MEMORANDUM

TO: MEMBERS OF THE PLANNING COMMISSION
THRU: BARBARA MCBETH, *A/CP*, CITY PLANNER
FROM: SRI RAVALI KOMARAGIRI, PLANNER
SUBJECT: JSP 18-74 SLI MEDICAL OFFICE BUILDING
DATE: OCTOBER 25, 2019

Re: Plan Review Center Report
Planning Review, dated 10/1/19
SLI Medical Office
42350 Grand River Avenue
Novi, MI 48375
JSP 18-74

PREVIOUSLY APPROVED SITE LAYOUT

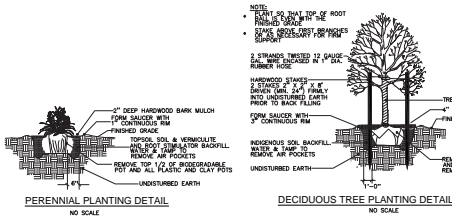
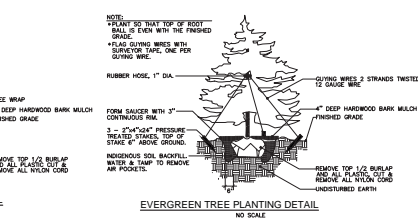
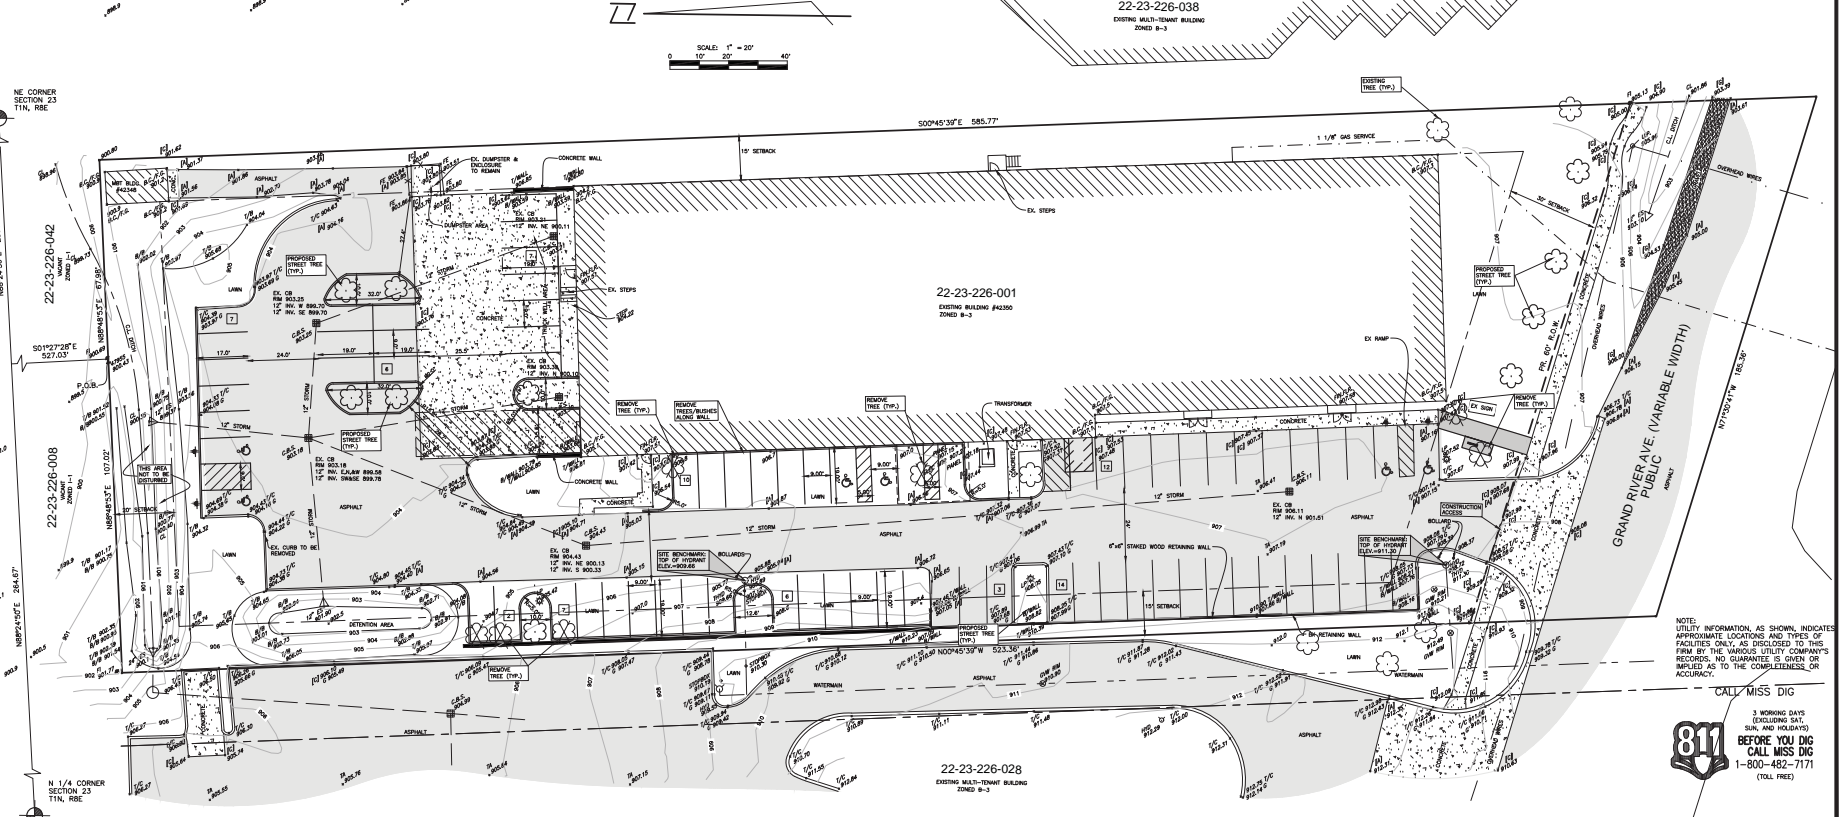
The approval motion required the applicant to submit a truck circulation diagram as part of the final site plan. In order to address this comment, the applicant noted that the removal of proposed landscape islands is warranted to allow reasonable space for truck maneuvering. The current revised plan no longer proposes end islands north of the building enclosed on the red box in the image below. The parking spaces are relocated to west as indicated in the blue box. The plan as currently proposed meets the Ordinance requirements and previously approved waivers, but it is slightly different from the site layout from the Planning Commission approval.

- a. The loss of two end islands resulted in reduction of green space by approximately 600 square feet of landscaped area and the removal of four proposed trees.
- b. The curb south of the loading area is now pulled back to enable safe truck turning movements, but it resulted in the loss of green space.

However, the applicant has closely worked with our landscape architect and addressed the entire comments listed in the review letters. All reviews are recommending approval at this time to move forward to electronic stamping sets.

REVISED SITE LAYOUT

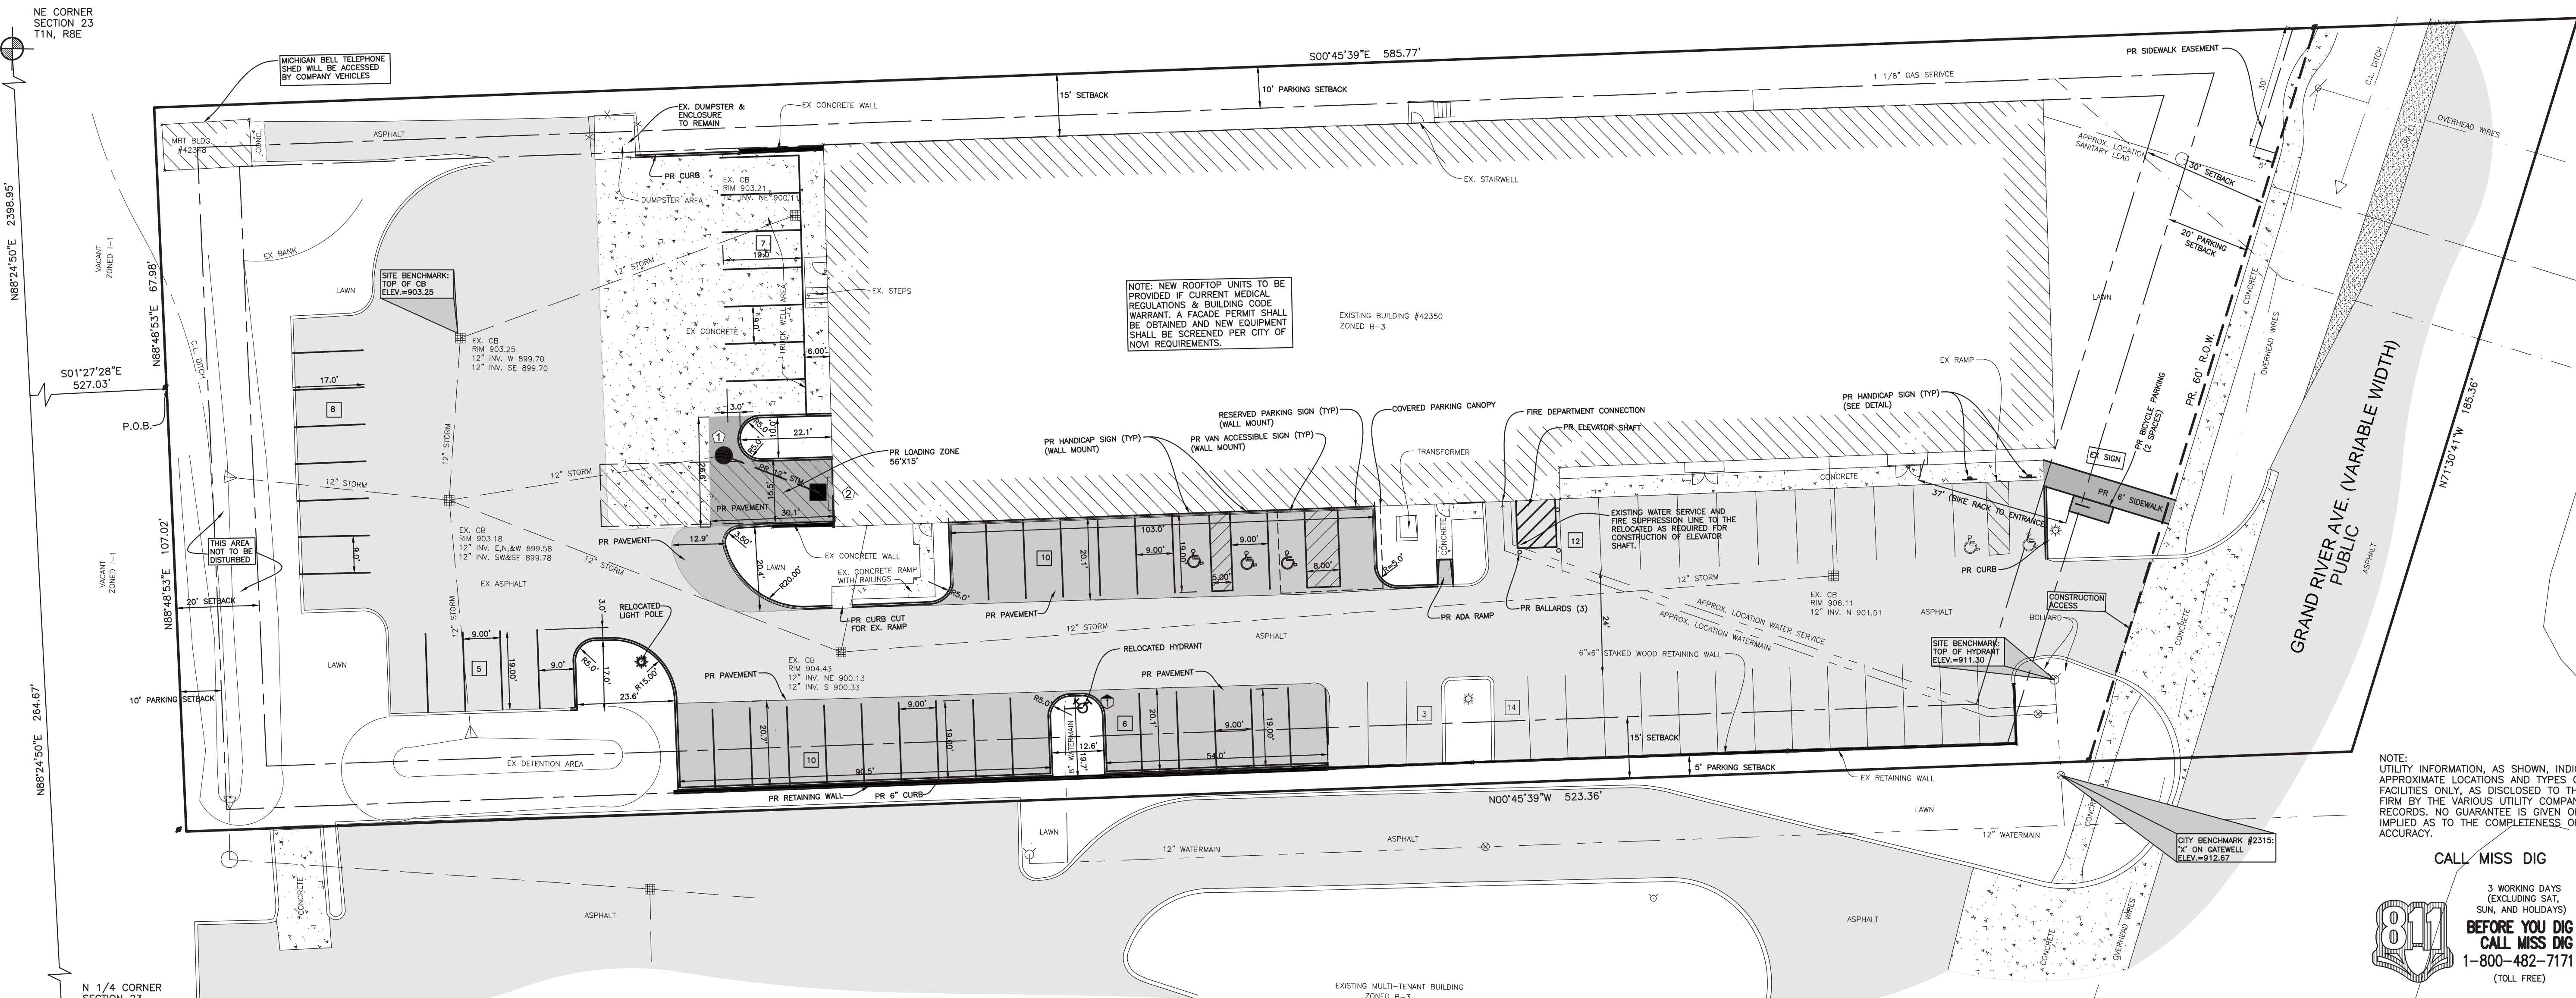
The revisions resulted in loss of green space in two locations:

INVERTED "U" BIKE PAD DETAIL
NOT TO SCALE

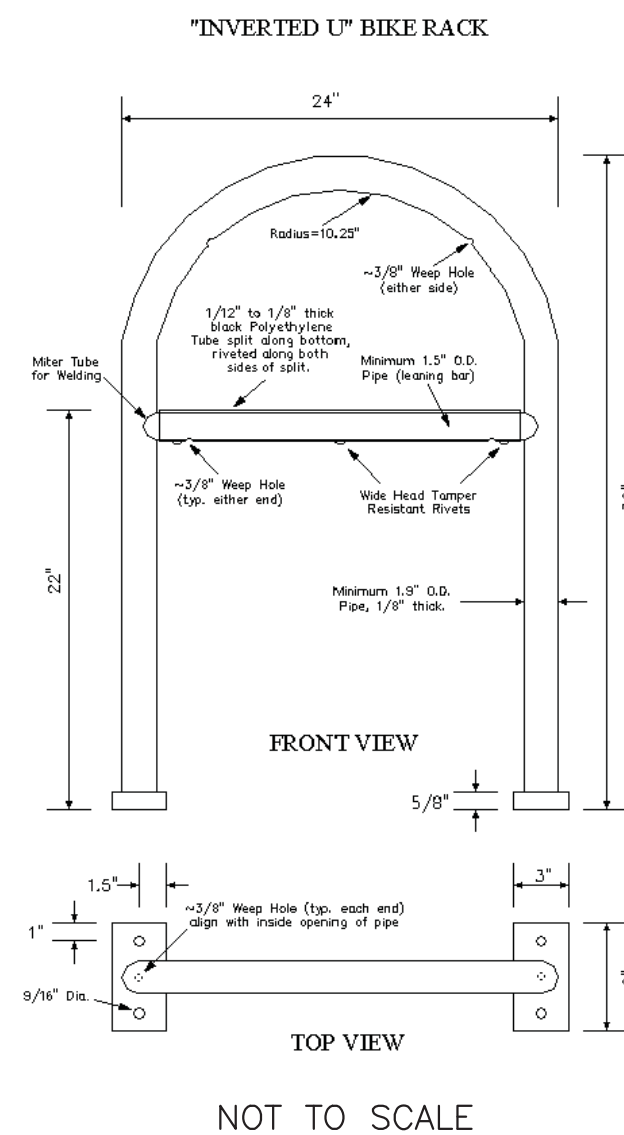
5. The applicant has indicated bicycle parking on the site plans. A detail of the layout has been provided, however, a bike rack has not been detailed and should be provided to ensure compliance with the city's zoning ordinance.

A bike rack detail has been added to sheet 5.
